# HISTORIC AND DESIGN REVIEW COMMISSION

February 03, 2021

**HDRC CASE NO:** 2021-032  
**ADDRESS:** 337 E SUMMIT AVE  
**LEGAL DESCRIPTION:** NCB 6882 BLK LOT 28, 29 & W 20 FT OF 30  
**ZONING:** R-5,H  
**CITY COUNCIL DIST.:** 1  
**DISTRICT:** Monte Vista Historic District  
**APPLICANT:** Samuel Asvestas/MONTEVISTA FOUNDATION INC  
**OWNER:** Samuel Asvestas/MONTEVISTA FOUNDATION INC  
**TYPE OF WORK:** Roof replacement, window replacement  
**APPLICATION RECEIVED:** January 19, 2021  
**60-DAY REVIEW:** Not applicable due to City Council Emergency Orders  
**CASE MANAGER:** Stephanie Phillips

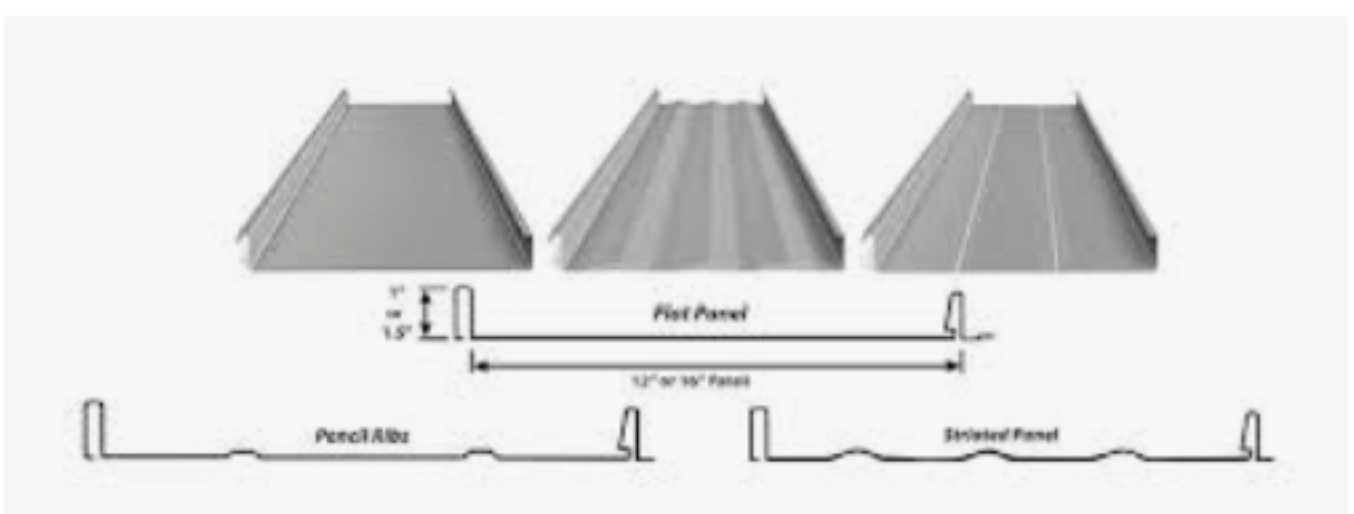
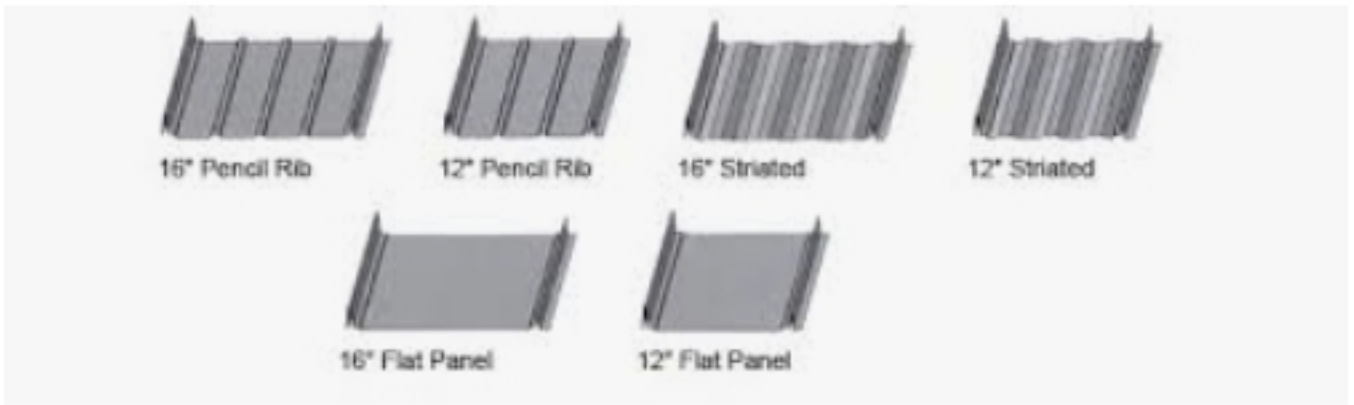
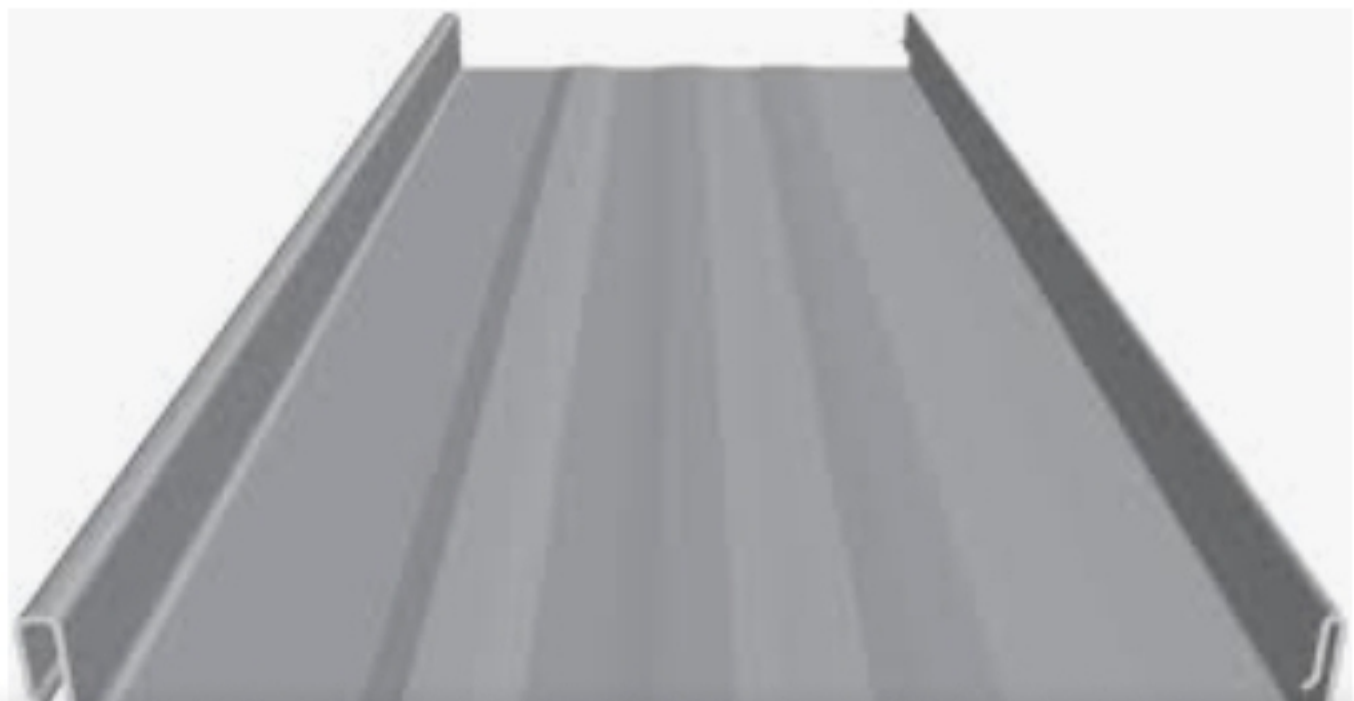
- d. ROOF REPLACEMENT – According to the Guidelines for Exterior Maintenance and Alterations 3.B.vi., metal roofs should only be installed on structures that historically had a metal roof or where a metal roof is appropriate for the style, construction period, or district. Staff finds that a metal roof is not a material rooted in the historic precedent of the development of this portion of the neighborhood. If approved, this house would be the only one of its construction era on this block with a metal roof. Staff does not find the roof replacement consistent with the Guidelines.

Item 1, Staff does recommend the replacement of the shingle roof with a metal roof based on findings a through d. The replacement of the roof in-kind with new asphalt shingles is eligible for administrative approval.

- i. That the applicant installs a standing seam metal roof featuring panels that are 18 to 21 inches wide, seams that are 1 to 2 inches high, a crimped ridge seam, and a standard galvalume finish. Panels should be smooth without striation or corrugation. Ridges are to feature a double-munch or crimped ridge configuration; no vented ridge caps or end caps are allowed. An on-site inspection must be scheduled with OHP staff prior to the start of work to verify that the roofing material matches the approved specifications. All chimney, flue, and related existing roof details must be preserved.

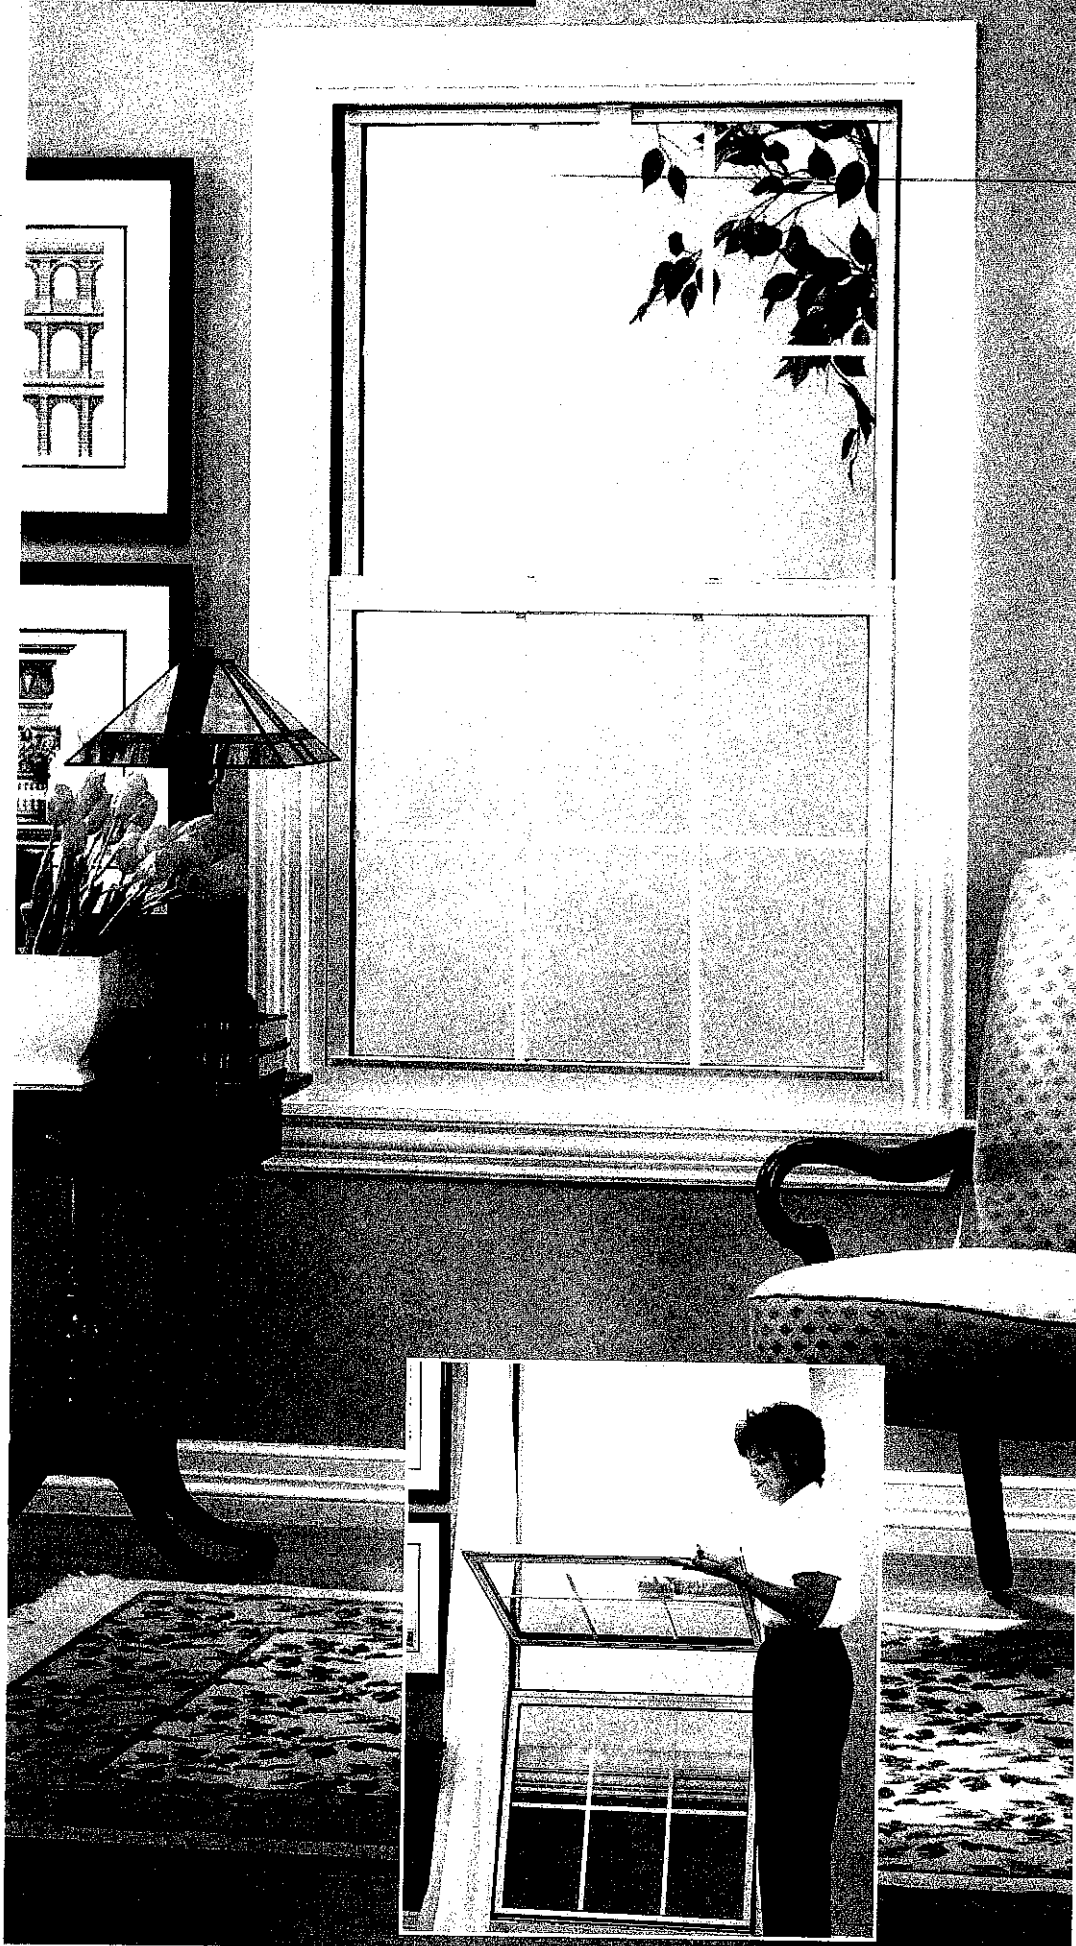
- f. **WINDOW REPLACEMENT** – The applicant has requested to replace all existing aluminum windows in the primary structure with new windows, with the exception of the double-height windows located to the right of the front door. The aluminum windows will match the proportion, configuration, detailing, and inset of the existing windows as closely as possible, but will be black in color instead of the existing aluminum silver finish. The applicant has noted that several of the windows exhibit evidence of improper repairs, painting of the exterior frames, and the deterioration or loss of functional elements. Based on these observations, staff finds that the replacement with the requested product is acceptable and will not result in the loss of character defining features or high-quality historic material.

Item 2, Staff recommends approval based on findings a through b with the following stipulations:

- i. That the replacement product matches the existing proportion, dimensions, proportion, configuration, and inset of the existing windows as closely as possible. Existing openings on the structure should not be enlarged or minimized to accommodate a replacement product. A window schedule and detailed product specifications shall be submitted to staff for review and approval that indicates all configurations to be installed in the structure.
